NHTSA:25V-673

Winnebago Towable: CAM0000044

**SUBJECT: Bedroom Shelf May Fail due to Improper Securement**

Winnebago of Indiana has decided that a defect which relates to motor vehicle safety exists on certain 2025 and 2026 Access models. These vehicles were manufactured **December 26, 2024**, through **May 2, 2025**.

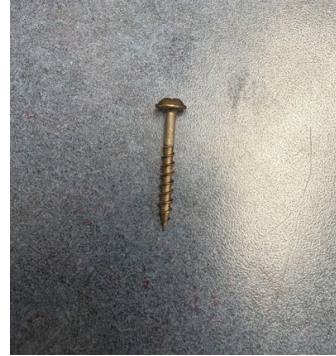
- 1. Inspect the shelf to ensure that it is secured to the top cleat, the sidewall, and RHF wardrobe**

- 2. Install 3 screws into the top stile going into the shelf and into the off-doorside sidewall. Then install 3 screws going into the shelf from the top of the stile.**

- 3. Install cleat on the bottom of the left side of the shelf, securing with 3 screws into the sidewall backer and 3 screws going up into the shelf.**

- 4. Repeat on the right side. Secure the cleat to the bottom side of the shelf and into the backer in the wardrobe.**
